STAFF REPORT

HISTORIC DOWNTOWN ADVISORY COMMISSION

**1. CERTIFICATE OF APPROPRIATENESS**

Applicant: 3 Pillar Homes  
Location: 67 Grace Dr S  
Zoning: DB – Downtown Business District  
Request: Review and approval of a proposed single-family residence.

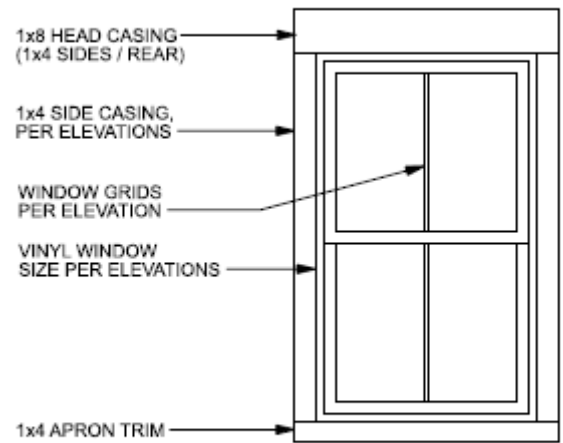
- Roof – New Construction (PAG, pg. 38)
  - “New construction in the Historical District should use the roof forms and slopes typical to the City. These roof types should be used in an appropriate manner and location.”
  - “Gable roofs are most appropriate for new construction in the Historic District. Their breadth, length, and slope should be similar to those of existing gable roofs, as excessively wide, long or steeply pitched gables would not be appropriate.”
    - Proposed Massing: Gabled roof with dormers.
    - Staff Comments: The massing is consistent with the guidelines.

### ENLARGED WINDOW ELEVATION

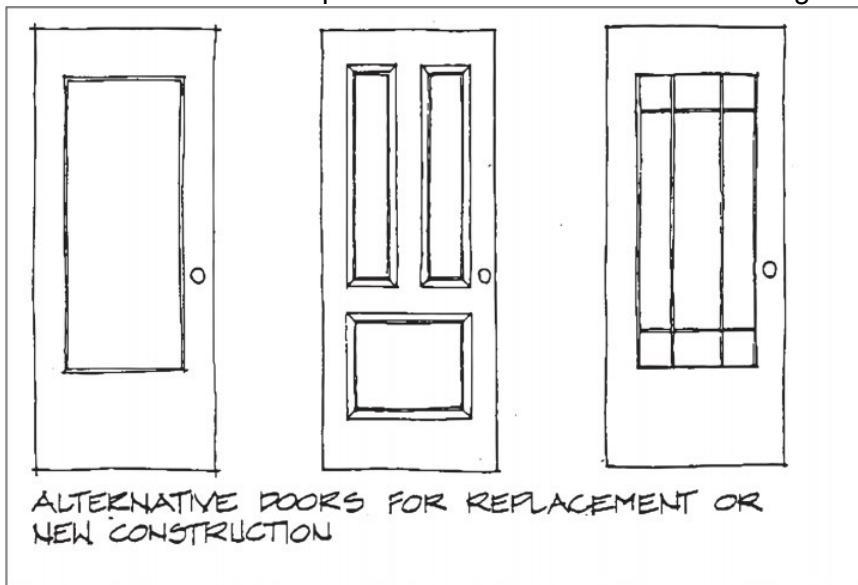
- “New construction within the Historic District should use window types and proportions characteristic of Powell. Double-hung windows in tall, thin proportions are appropriate in almost all types of Powell buildings.”
  - Proposed Windows: See drawing set and window elevation provided.
  - Staff Comments: The windows on the front elevation are appropriate, with the exception of the windows above the garage, and the small window above the front doors. Several windows on the north and south elevation do not meet the proportions of the guidelines. Staff recommends the applicant work with the Architectural Advisor and Staff to rectify.

- Proposed Doors: See drawing set, and note that exterior door trim is similar to the window elevation provided above.
- Staff Comments: The front door is not consistent with the guidelines, as the proposed door is not a single front door, but a double, and the design contains two wood panels with glazing above, rather than the typical four wood panel design or single glazed panels above a wood one.
